**TOWN OF LEESBURG
NOTICE OF TOWN COUNCIL PUBLIC HEARING
TO CONSIDER SPECIAL EXCEPTION APPLICATION
TLSE-2012-0005
OAKLAWN GAS STATION**

**TOWN OF LEESBURG
TOWN COUNCIL PUBLIC HEARING MEETING**

Subject: TLSE-2012-0005, Oaklawn Gas Station, a special exception application to allow a service station, convenience store and car wash in the PEC zoning district.

Figure 2. Pedestrian Pathways at the Site

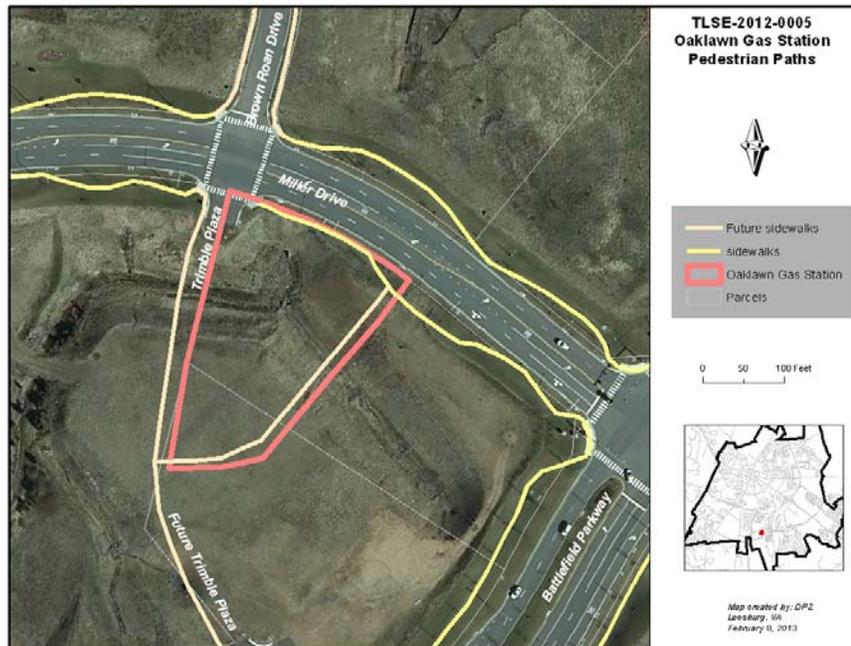
As currently laid out, one can question whether access to the store from Brown Roan Drive is as safe and convenient as possible (see Figure 2). While crosswalks are provided at the intersection of Brown Roan and Miller Drives, there is no sidewalk proposed from that intersection on the east side of Trimble Plaza leading to the store. Staff did not recommend the sidewalk on the east side of Trimble Plaza because of the conflict it creates for pedestrians and vehicles at the main driveway entrance to the service station. As discussed later in this report, staff proposes a redesign of the site layout that should improve pedestrian access and safety.

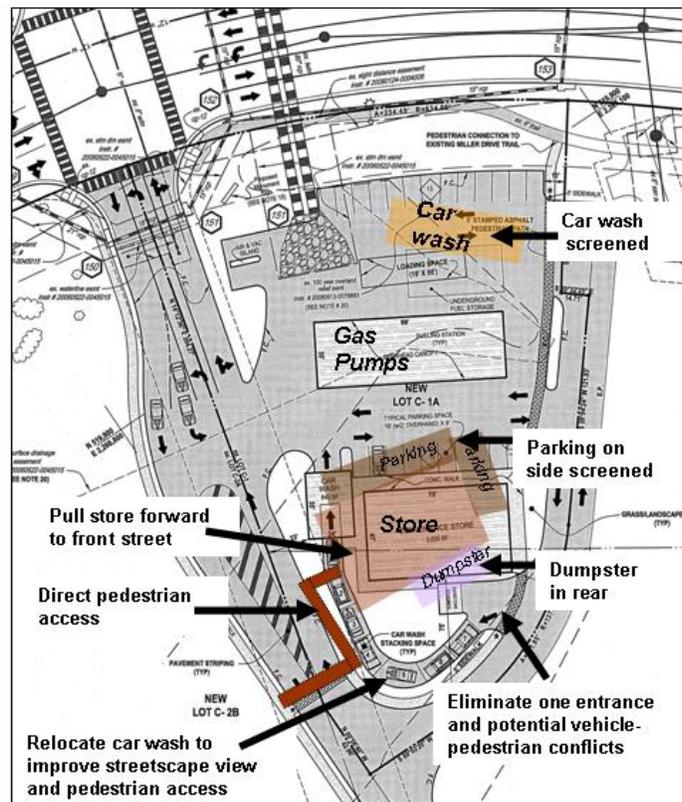
4. Reduce conflicts between loading, trash service, and pedestrians.

- Relocate the trash dumpster and loading area away from pedestrian travel paths and car wash stacking.

Figure 5. Alternative Site Layout Example

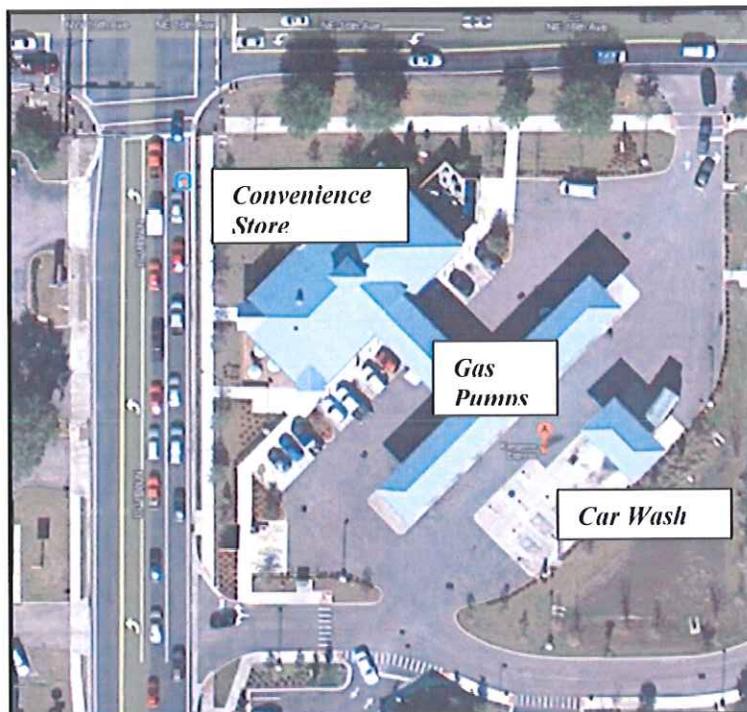
3. **Site Design:** The Town Plan states “site design should conform to H-2 district design guidelines” (Site Design and Location Criteria #6, p. 6-25). Staff’s assessment of the site design indicates that this does not meet H-2 design guidelines for building size, scale, and orientation nor for building appearance. While building appearance is addressed at the time of site plan, the size, scale, and orientation of the building must be addressed now during the special exception process (otherwise, a site plan would not be in “substantial conformance” with the approved special exception plat). A more thorough discussion of the H-2 District Design issues is provided under item “B” of this Staff Analysis section of this report. An example of an alternative site layout that meets H-2 Guidelines is shown in figure 5.

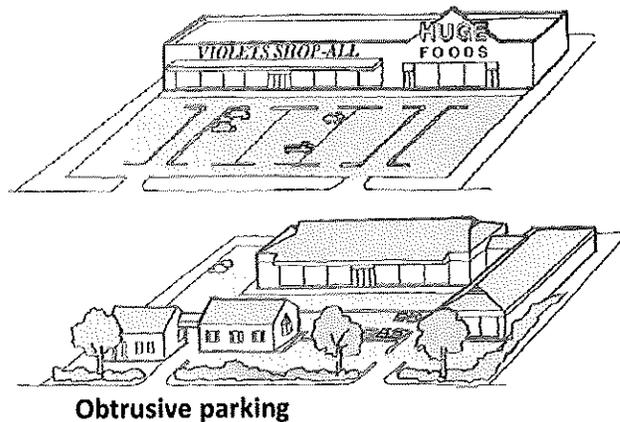
Approaching from the south is essentially facing the rear of the building, the car wash entrance and the dumpster enclosure. The sides of the convenience store are also blank and have no human scale detailing or screening. The car wash entrance is prominent as those entering to the west side will drive towards it as they pass on the west side to find the site entrance.

- ◆ The current siting demands that all facades have more of a presence or are screened appropriately.

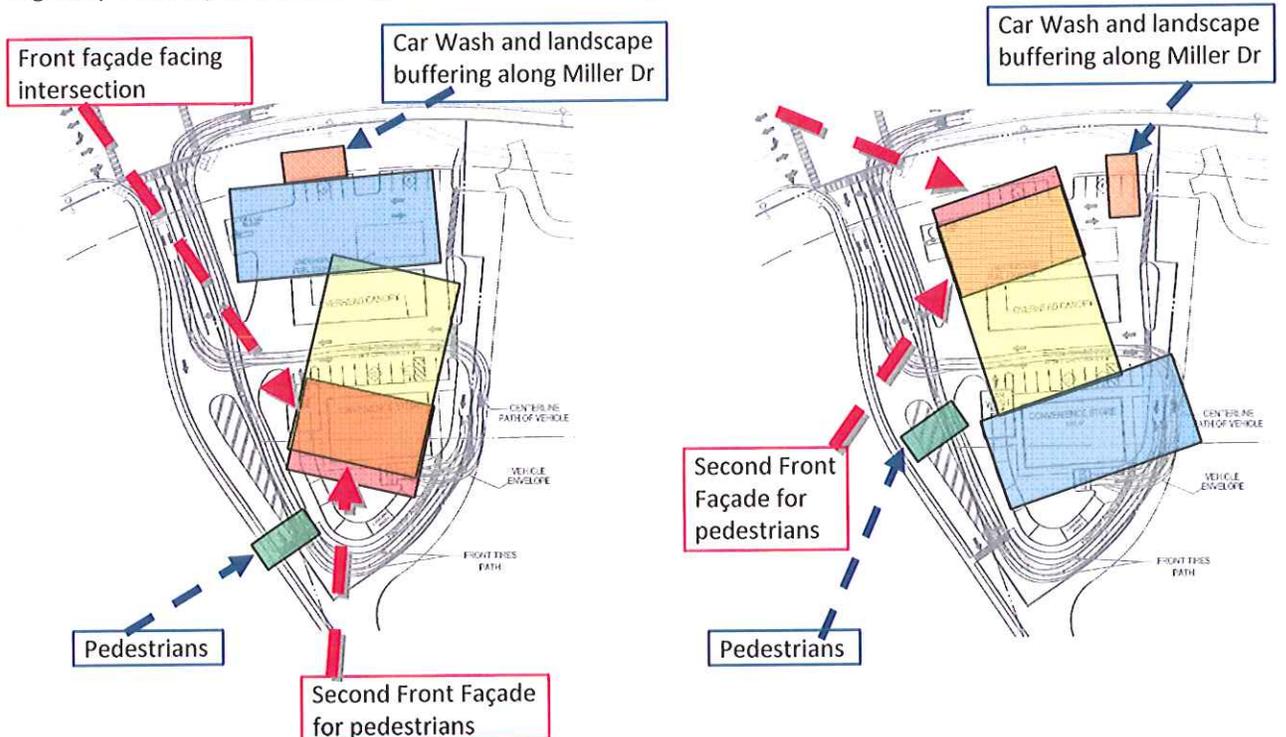
Above left is one example of a slight siting change by moving the car wash up to inside the berm and landscape buffer with proper screening and allowing safe pedestrian crossing at the SW corner that would meet the H-2 guidelines, but it is unknown if this would also meet all other site requirements.

Above right is an example of siting change that would meet the H-2 guidelines, but this is not possible as the site is currently bounded.

Figure 5. Alternative Site Layout Example

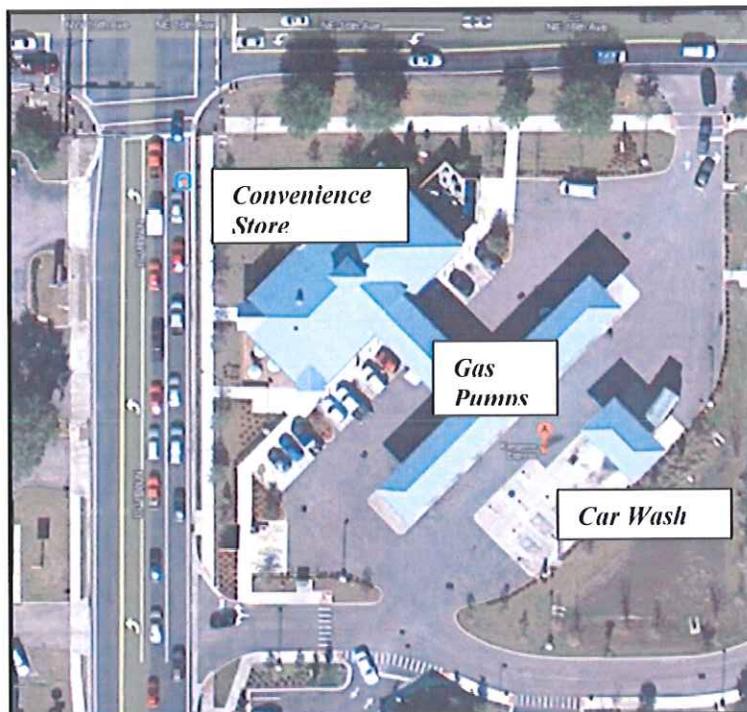
Staff has provided the applicant with examples of existing development where this type of use is developed in a manner that is more consistent with Gateway Design corridors (see example below in Figure 5). However, the applicant has stated they are unwilling to alter the site layout. They have indicated that their experience with service stations shows that for operational ease the car wash and pumps must both be easily accessible to employees from the convenience store in the manner proposed by their design. Staff notes there are numerous examples locally and nationally of alternative designs including ones where the car wash is not adjacent to the convenience store (see Figure 6 as an example).

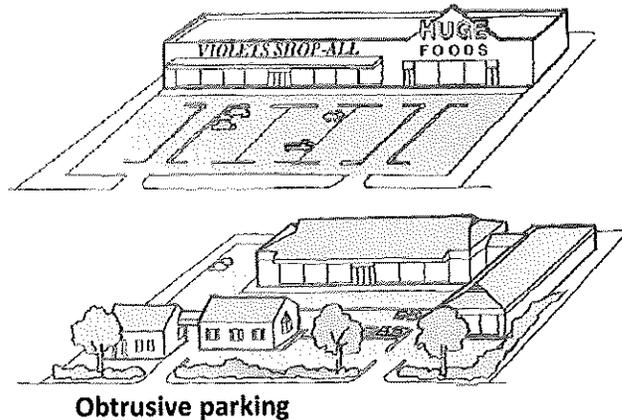
Approaching from the south is essentially facing the rear of the building, the car wash entrance and the dumpster enclosure. The sides of the convenience store are also blank and have no human scale detailing or screening. The car wash entrance is prominent as those entering to the west side will drive towards it as they pass on the west side to find the site entrance.

- ◆ The current siting demands that all facades have more of a presence or are screened appropriately.

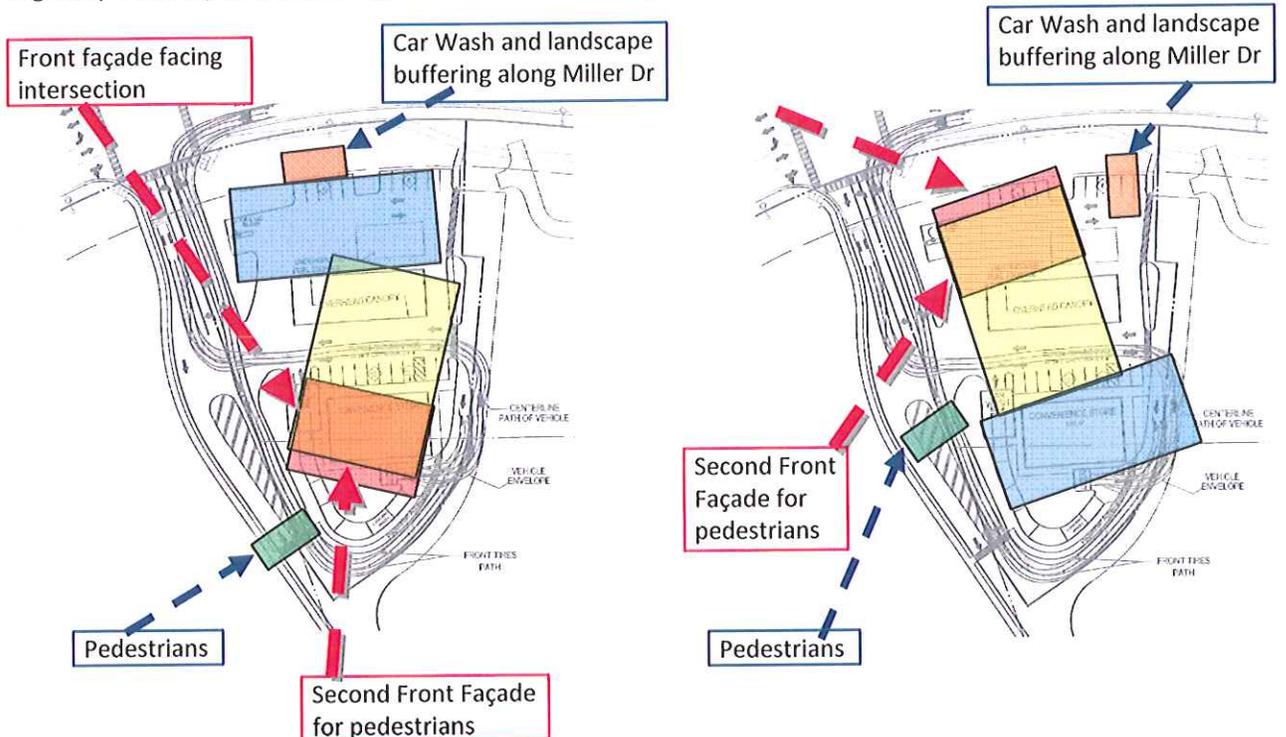
Above left is one example of a slight siting change by moving the car wash up to inside the berm and landscape buffer with proper screening and allowing safe pedestrian crossing at the SW corner that would meet the H-2 guidelines, but it is unknown if this would also meet all other site requirements.

Above right is an example of siting change that would meet the H-2 guidelines, but this is not possible as the site is currently bounded.
